# United States Patent and Trademark Office

APPLICATION NO.	FILING DATE	FIRST NAMED INVENTOR	ATTORNEY DOCKET NO.	CONFIRMATION NO.	
10/784,874	02/24/2004	Yozo Hotta	03500.018005	8293	
5514 75	90 05/26/2006	05/26/2006		EXAMINER	
FITZPATRICK CELLA HARPER & SCINTO			WALSH, RYAN D		
30 ROCKEFELLER PLAZA NEW YORK, NY 10112			ART UNIT	PAPER NUMBER	
<b></b>			2852		
			DATE MAILED: 05/26/2006

#### **DETAILED ACTION**

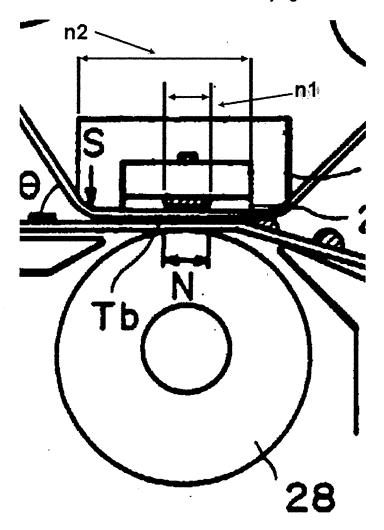
Regarding claim 1, Izawa teaches, "An image heating apparatus (Abstract) for heating an image formed on a recording material, comprising: a conveying roller (10) for conveying the recording material; heat supply means which supplies heat to said conveying roller, said heat supply means (20) being in contact with an external periphery of said conveying roller to form a heating nip portion [0055]; back-up means (30) which forms a conveying nip portion (N) in cooperation with said conveying roller

for nipping and conveying the recording material; wherein, in a rotating direction of said conveying roller, the heating nip portion has a width larger {([0133],Ln.1-6) and see (Fig. 15, ref. character H) is larger than N} than a width of the conveying nip portion, and a total pressure applied to the conveying nip portion is larger than a total pressure applied to-the heating nip portion [0134], wherein said heat supply means (20) includes a heat generating member (21), a holder (24) for supporting said heat generating member, and a flexible rotary member (19) nipped between said conveying roller (10) and said heat generating member (21) and rotating (by 17 & 18) around said holder (19 is around the holder)." Izawa does not teach, "the heating nip portion includes a first heating nip portion which is formed between said heat generating member and said conveying roller and a second heating nip portion which is formed between said holder and said conveying roller, a position of the first heating nip portion and a position of the second heating nip portion being different from each other in a direction which said conveying roller moves." However, Yamamoto teaches, "the heating nip portion (Fig. 4, ref. char. N) includes a first heating nip portion (n1 see Figure below) which is formed between said heat generating member (22) and said conveying roller (28) and a second heating nip portion (n2 see Figure below) which is formed between said holder (27) and said conveying roller (28), a position of the first heating nip portion and a position of the second heating nip portion being different from each other in a direction which said conveying roller moves (See Fig. 4)." It would have been obvious to one of ordinary skill in the art at the time the invention was made to modify Izawa's invention to include the heating nip portion includes a first heating nip portion which is formed between said

Regarding claim 2, Izawa teaches, "An image heating apparatus according to claim 1, wherein said conveying roller has an elastic layer (ref. # 12, and [0113], Ln. 2-3), and a maximum recess amount formed in said conveying roller by said back-up means (30) is larger than a maximum recess amount formed in said conveying roller by said heating means (20)." (See diagram below)
